Fire technical assessment

Name of sponsor: Bygcom A/S
Product name: Fermacell 1S20 – EI60
File no.: PHA11192H
Date: 03-06-2019
Pages: 4 **Encl.:** 1
Ref: MKL / NOL

Asymmetrical non-loadbearing wall

9. Fermacell 1S20 - EI60 på 10+12mm-12mm Fermacell fiber gips, Bygcom studs min. 2X75x1.2mm cc max. 600mm og 2 x stenuld på minimum 30kg/m³. Max. 3m høj

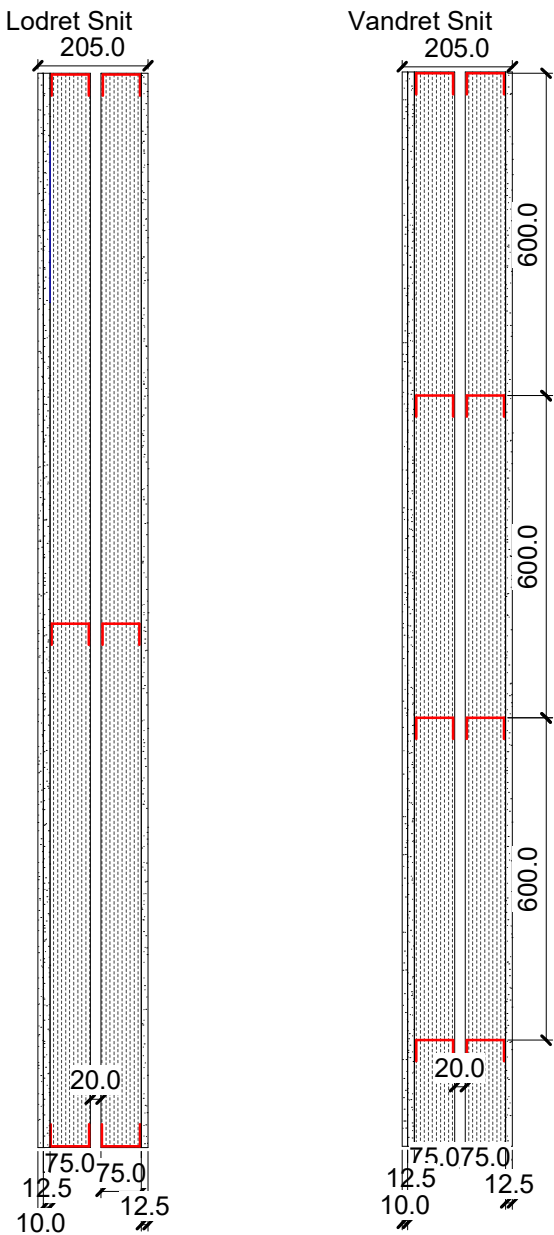
The construction shown on the attached drawing consist of two layers of Fermacell fibre board (10 + 12.5 mm) on one side and one layer of 12.5 mm Fermacell fibre board on the other side of two rows of c/c 600 mm steel studs with a width of 75 mm and a steel thickness of 1.2 mm designated Bygcom 75x1.2. The two rows of studs are placed 20mm apart. Stone wool insulation with a nominal density of at least 30 kg/m³ is mounted between both rows of steel studs.

The changes to the assessed wall is the type and thickness of the studs, the added extra row of studs with stone wool insulation and the added 10 mm Fermacell fibre board on one side. The change in stud type, the increase in stud thickness, the extra row of studs and the added 10 mm Fermacell fibre board will not deteriorate the performance of the wall and can in some cases improve the stability of a wall during a fire test.

Based on the given documentation, DBI assesses that the wall shown on the attached drawings fulfils the requirements for a non-loadbearing wall with the classification EI60.

- The following changes are allowed (taken from the DIAP in EN 1364-1:2015)
 - Decrease in height (max 3000 mm)
 - Increase in the thickness of the wall (minimum 205 mm thick)
 - Increase in the thickness of component materials
 - Increase in the studs width.
 - Decrease in linear dimensions of boards but not thickness
 - Decrease in stud spacing
 - Decrease in distance of fixing centres
 - Increase in the number of horizontal joints
 - Unlimited increase in the width of the wall
- All other details must be constructed as described in test report 2006-CVB-R0193
